Product/Process Change Notification [F-44.04]

PCN number	EU466
Issue date	2026.9.24
Submission date	2026.9.24
Change implementation date	2027.1.1
Production Site	JAE Philippines Inc
Type of change	Other (please specify)
Reason of change	Other (please specify)
Type of improvement	Other (please specify)
Change description	Change of glue additives for hot melt
Current cavities numbers / units number	N/A
New cavities numbers / units number	N/A
Affects	Material

Deviation Request Form		DR-26007	
		Part Description	MX65 series connector		
		Date of request:	Donnerstag, 24. September 2026		
		Project	MX55 series connector		
Customer Data		JAE Data			
Customer name:	TTI	JAE Requestor:	JAE Europe Ltd		
Customer site:		JAE Manufacturing Location:	JAE Philippines		
Customer contact:	Nina Sulimeenko	Manufacturing Quality contact:	Oya Yoshitaka		
e-mail address:	Nina.Sulimenko@de.ttiinc.com	JAE-EU Program Manager:	Daniel Clark		
Phone number:	49 8142 6680 - 709	JAE-EU Quality Manager	Grant Trowbridge		
Part Identification					
Part designation:	MX55A04C0015863	Supplier part number:	JAE part number(s): CBM-194392	Revision level:	
		Project code:			
Non Conformity Description					
Reason for the

耐熱性(105°C)

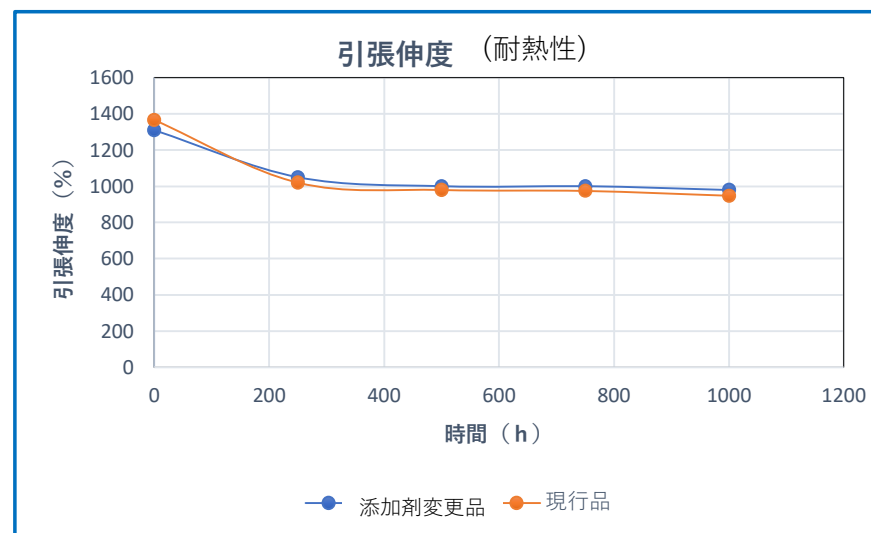
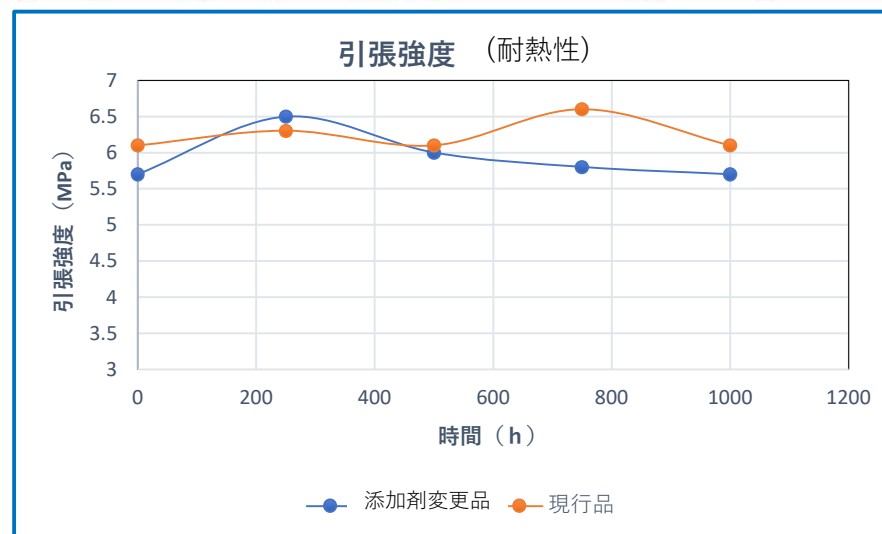
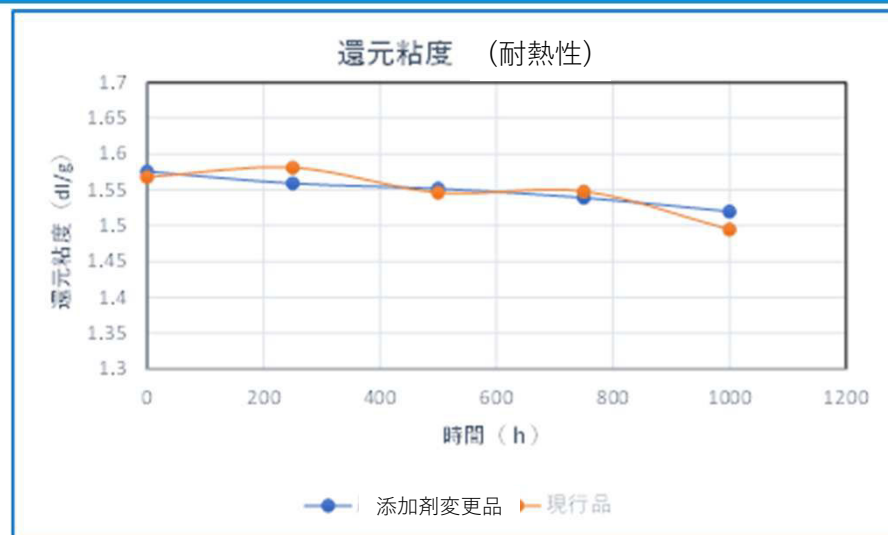
現行 GM-955-R02	新規 GM-955-R02改
添加剤処方	添加剤 A	添加剤 A
	添加剤 B	添加剤 B
	添加剤 C (廃番)	添加剤 D (代替)

※ベースポリエステルの変更はございません。

還元粘度 (耐湿熱性)

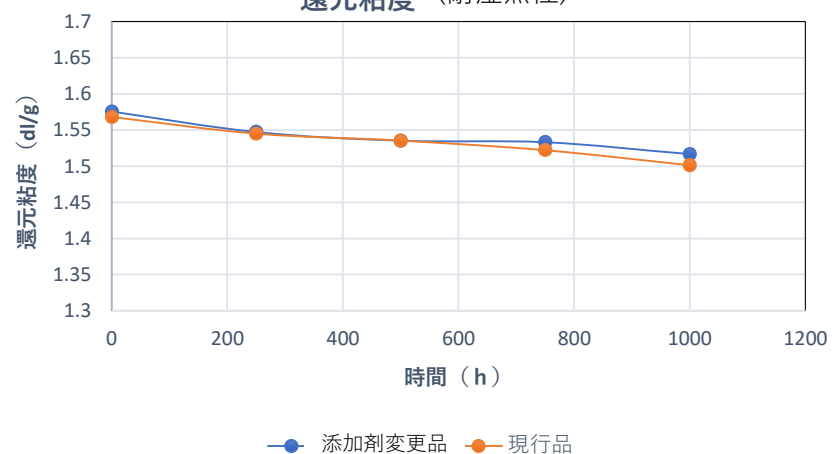
耐湿熱性(85℃×85%RH) ※グラフは弊社研究所測定値であり、保証値ではございません。東洋紡エムシー株式会社
